NRC QUESTIONS REGARDING SONGS 1 ATWS
FROM SUBMITTAL of JANUARY 29, 1988

ADDITIONAL COMMENTS SUBMITTED MARCH 7, 1988

NRC QUESTIONS REGARDING SONGS 1 SPDS
FROM SUBMITTAL OF APRIL 1, 1988

Schematic 1
 Model 8N13 Test Configuration
 Test Coil to Contacts

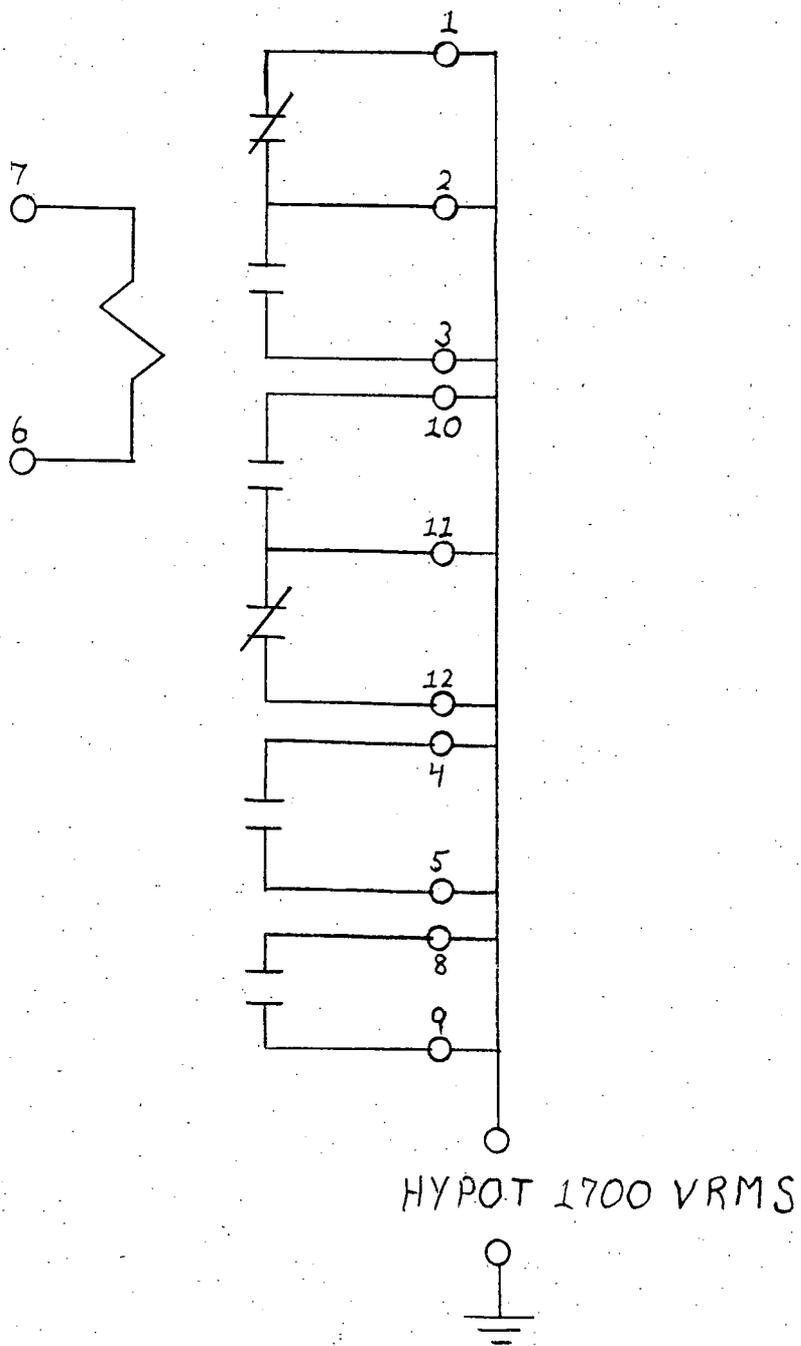
4. Provide test configuration schematics of the tests performed on the Model 8N13.

Test configuration schematics of the tests performed on the Model 8N13 isolation relay are included on the attached Schematics 1 and 2.

CUSTOM MODEL 2A0-VAI OR N-2A0-VAI VOLTAGE-TO-CURRENT CONVERTER
MODIFIED TO FUNCTION AS A VOLTAGE-TO-VOLTAGE CONVERTER
WITH 0 TO 10 VOLT OUTPUTS

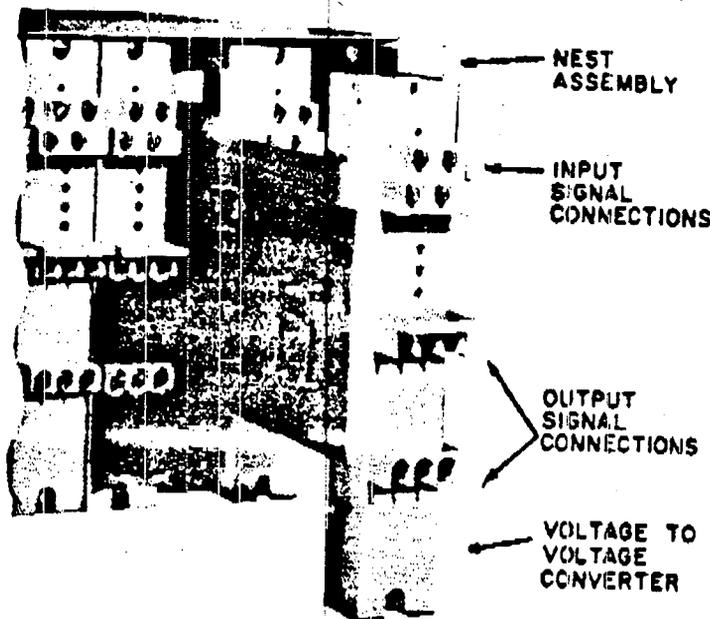
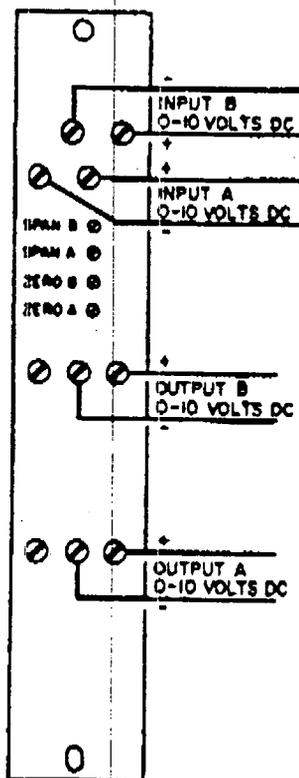
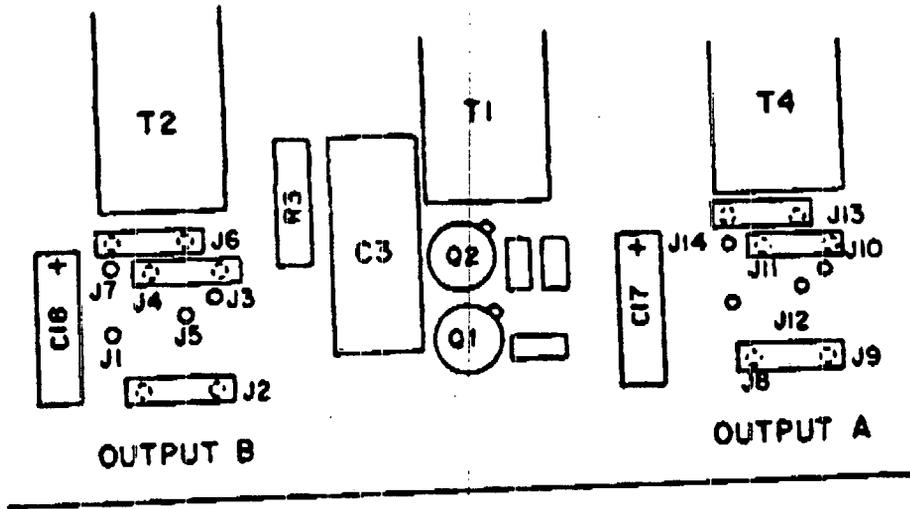
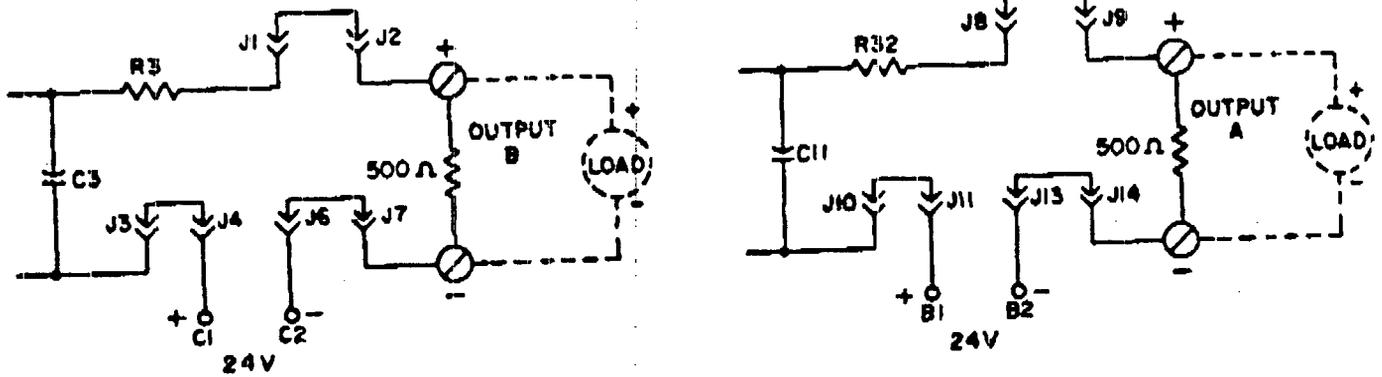
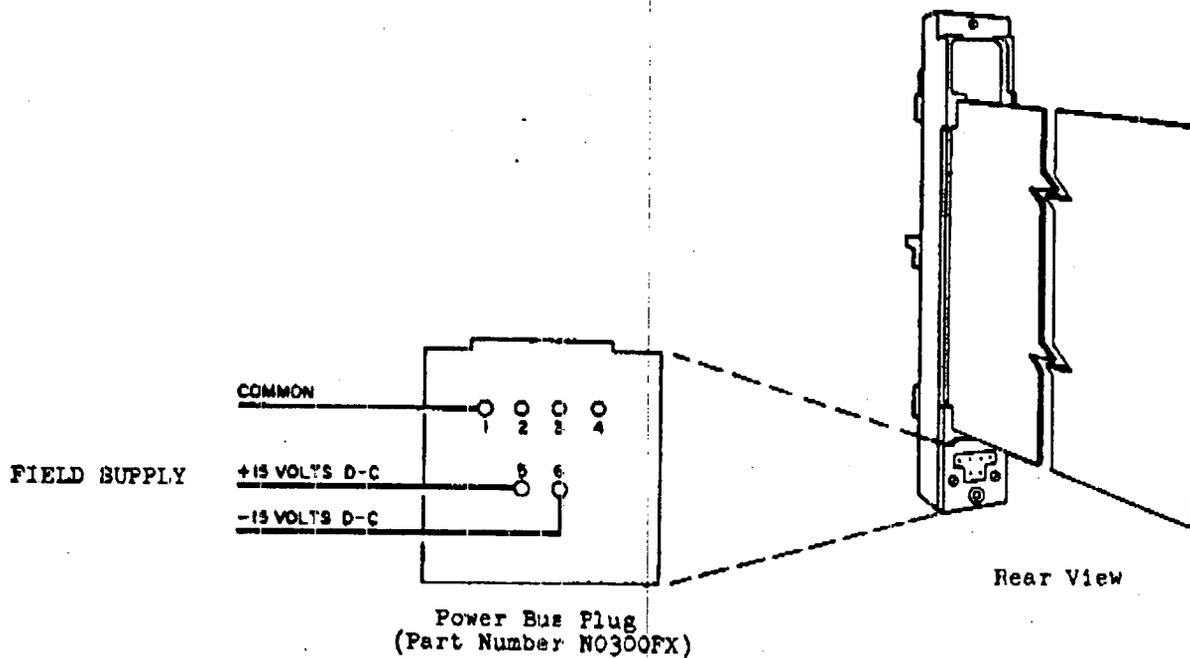
1. Provide a description/wiring diagram of ECEP 9206 which was used to modify the Foxboro 2AO-VAI isolator.

The attached Foxboro Bulletins SI-1-01762, TI-2AO-130, and MI-2AO-130 provide the requested description and wiring information for the analog signal isolator.
